## **3.0 DESIGN OF STRUCTURES, COMPONENTS, EQUIPMENT AND SYSTEMS**

Section 3.1 of the Levy Nuclear Plant (LNP) combined license (COL) Final Safety Analysis Report (FSAR), Revision 9, incorporates by reference Section 3.1, "Conformance with NRC General Design Criteria," of Revision 19 of the AP1000 Design Control Document (DCD). In addition, in the LNP COL FSAR, the applicant provided the following:

**Figure 3.7.1-1. Comparison of the horizontal FIRS at the elevations of -7 m (-24 ft) and +3.3 m (+11 ft) calculated by the NRC staff, the horizontal FIRS at the same elevations calculated by the applicant, and the Westinghouse CSDRS.**

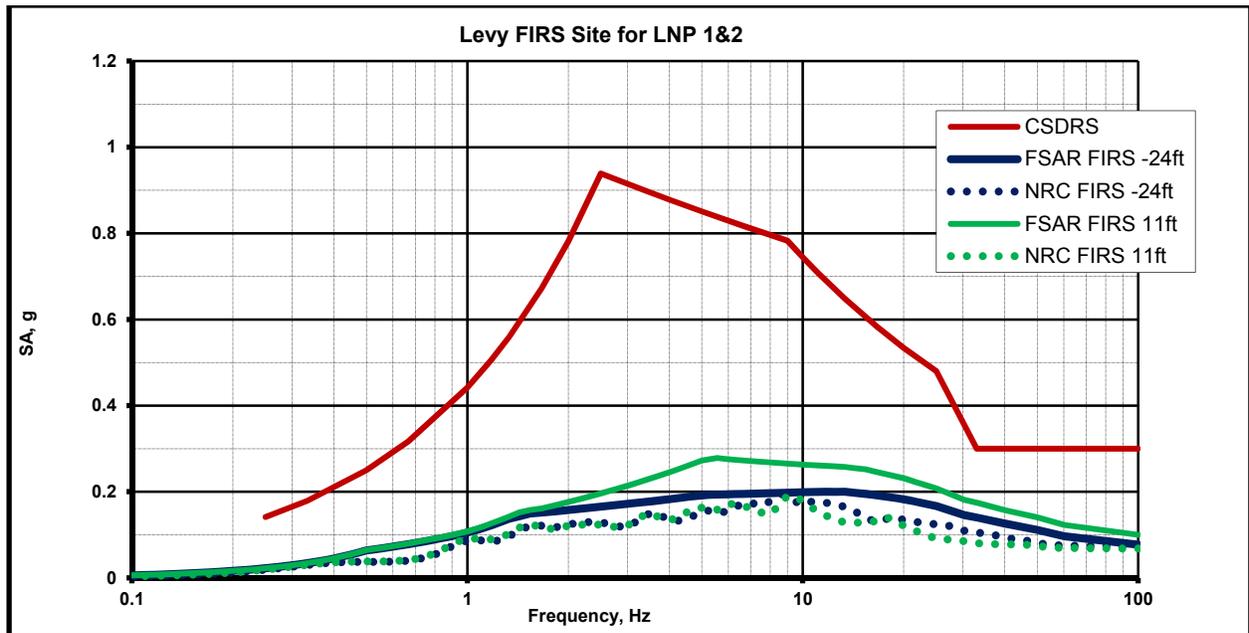
The staff performed confirmatory calculations for both FIRS using the same approach as described above for the PBSRS. For the  $V_s$  profiles for the FIRS at the elevation of -7 m (-24 ft), the staff used profiles shown in FSAR Tables 2.5.2-222 and 2.5.2-223. Modifications to these  $V_s$  profiles were made by removing the layers in the upper 15 m (50 ft). Figure 3.7.1-1 compares the staff's calculation of the FIRS with the CSDRS and FSAR (Fig.3.7-201).

The set of site amplification functions for the FIRS at the elevation of +3.3 m (+11 ft) was calculated using 10.7 m (35 ft) of concrete with  $V_s$  of 1066 m/s (3500 ft/s) (FSAR Table 2.5.4.5-201) on the top of profile used for the FIRS at the elevation of -7 m (-24 ft). Figure 3.7.1-1 compares the staff's calculation of FIRS with CSDRS and the applicant's from the LNP Unit 1 and 2 FSAR (Figure 3.7-205).

The staff's calculation of the FIRS at both elevations of -7 m (-24 ft) and +3.3 m (+11 ft) are enveloped by the applicant's FIRS and by the CSRDS. Therefore, the staff concludes that in the frequency range significant to a reactor's structures, systems, and components, there are no significant differences between the staff's and the applicant's calculated amplification functions and FIRS for the  $10^{-4}$  and  $10^{-5}$  hazard levels.
